Randwick Local Planning Panel (Electronic) Meeting

Thursday 13 February 2025

Development Application Report No. D4/25

Subject: 7 Hill Street, Coogee (DA/932/2024)

Figure 12: Markup of proposed ground floor plan (Source: Smart Design Studio with Council officer markup)

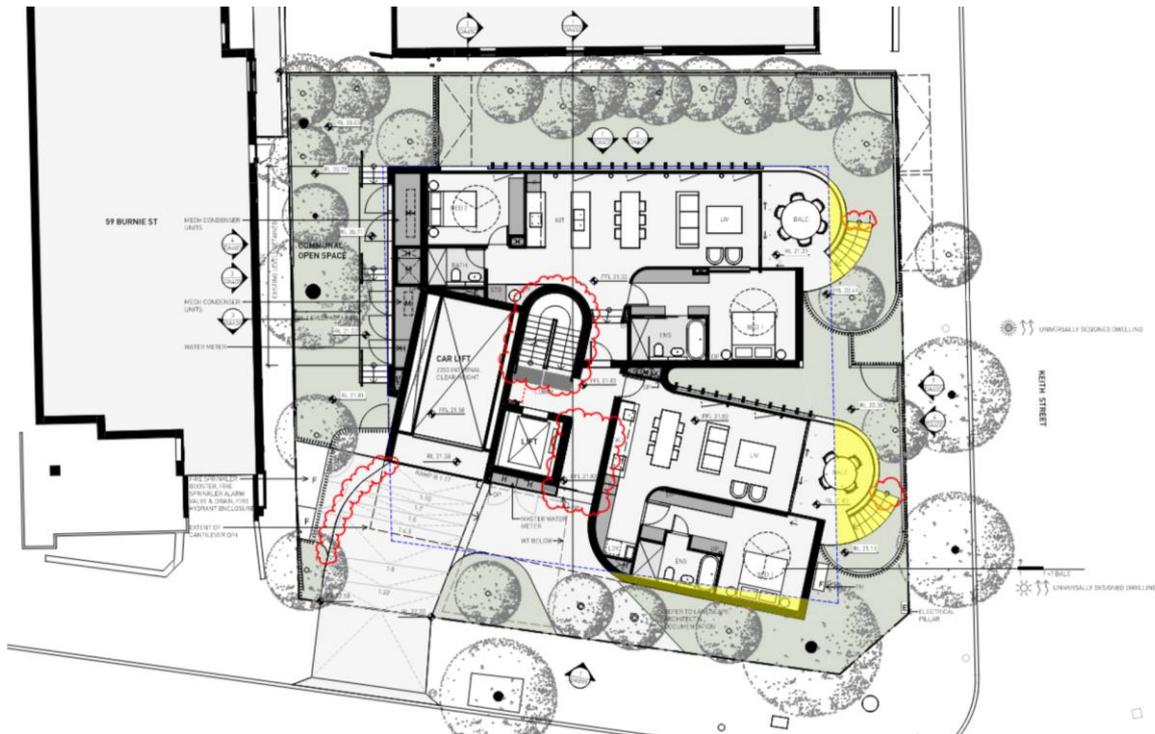
As shown in Figure 12 below, the proposed front setbacks (to Clovelly Rd and Keith St) are generally consistent with the alignment of neighbouring properties (i.e. No. 59 Burnie St and No. 2 Keith St) and the minimum 3m requirement. However, a minor portion of the building (south-east corner) encroaches within the southern setback area and a minor portion of the balconies (and access stairs) encroach within the eastern setback area. These areas relate to minor portions of the building which provide articulation to the street façades.

Minor numeric non-compliance is acceptable in this instance noting that the non-compliant element does not directly result in any adverse impacts (i.e. overshadowing, overlooking, or view impacts). Insistence on strict compliance with the 3m setback control would not provide an improved outcome and would result in non-compliant bedroom dimensions and balcony sizes.

Consistent with the objectives of Part C2, Section 3.4 of RDCP 2013, a consistent rhythm of street setbacks and front gardens is provided and contributes to the character of the locality.

Figure 14: View from sun diagrams – 8am to 1pm (Source: Smart Design Studio)

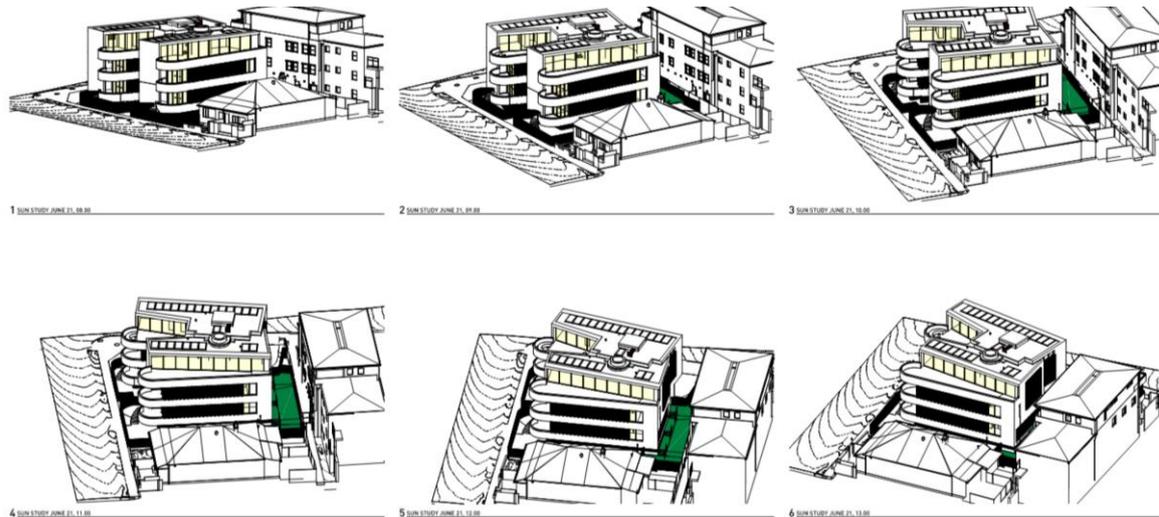
Pursuant to Part C2, Section 5.1 of RDCP 2013, living areas and private open space areas should receive a minimum of three (3) hours of direct sunlight between 8am and 4pm, midwinter.

As shown in Figure 14, three (3) hours of sunlight will be provided to a portion of the living room windows and balconies of all proposed apartments between 8am and 11pm (at midwinter). Additional solar access is provided to the upper apartments in excess of the minimum three (3) hour requirement.

Figure 15: Elevational shadow diagrams (59 Burnie St) – 8am to 1pm (Source: Smart Design Studio)

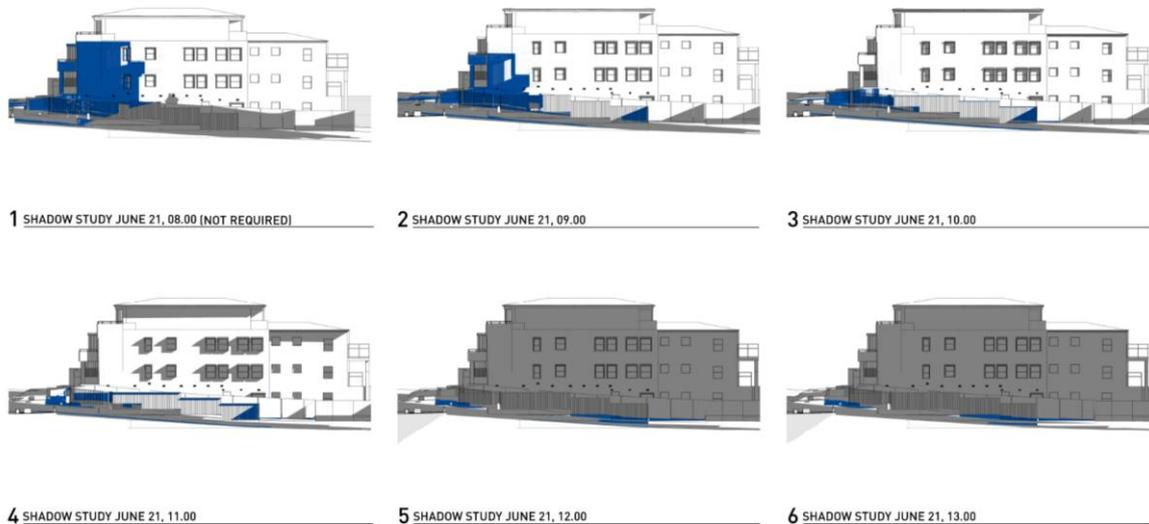
Relative to the existing situation, the proposal will result in additional overshadowing of a living room window and a portion of the front balcony of 5/59 Burnie St at 8am. Notwithstanding, as shown in Figure 15, suitable solar access will be provided to the window and balcony for the remainder of the morning.

Figure 21: Markup of proposed Level 2 plan, with conditioned privacy screen shown in red (Source: Smart Design Studio with Council officer markup)

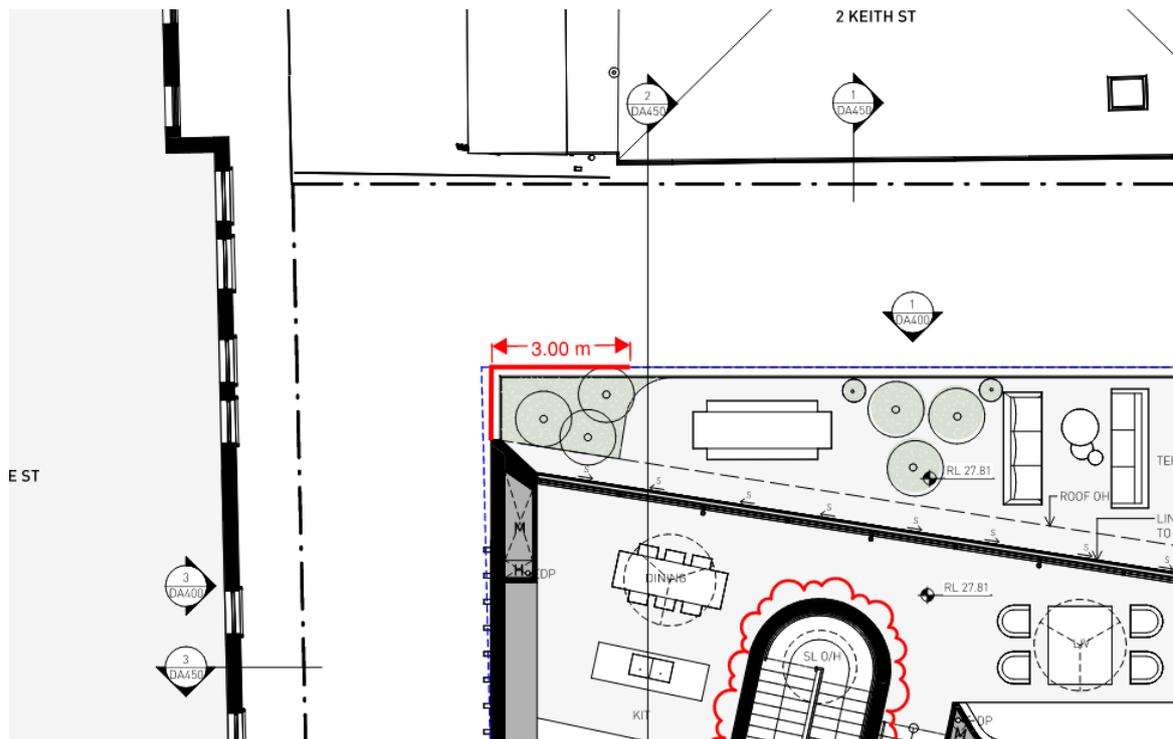
At second floor level, the proposed northern balcony (RL27.81 floor level) is suitably located above the ridge height of the dwelling at No. 2 Keith St (RL26.52 roof ridge). To prevent overlooking to the adjacent window openings at No. 59 Burnie Street and to the rear POS area at No. 2 Keith Street, a condition is included to ensure that privacy screens are provided to the western edge and a portion

of the northern edge of the balcony (refer Figure 21). The proposed southern balcony is oriented towards the east (i.e. Keith St), away from neighbouring properties.
